Product Service Group CE Audio

CHANGES DURING PRODUCTION

P2002 110/135W MODULE - MAINS BOARD

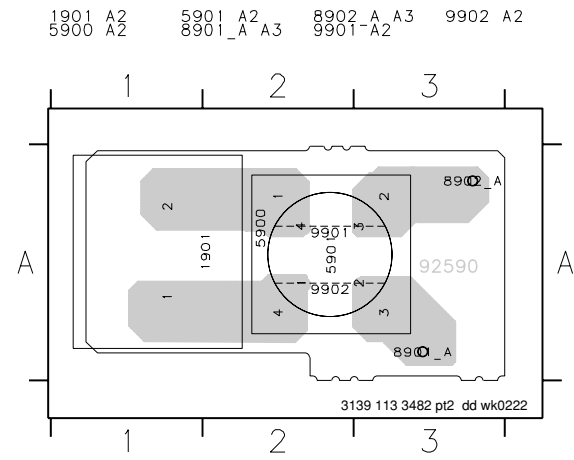
*From production week 0218 onwards new Mains & Mains Socket pc boards is introduced due to process improvement. The board can be recognized by the printing mark 12NC - 3139 113 34822. For this reason new pc board layout is enclosed.

*From production week 0226 onwards the following has been changed due to supply change.

Change 7951	4822 130 41327	BC327-40
7952	4822 130 41327	BC327-40
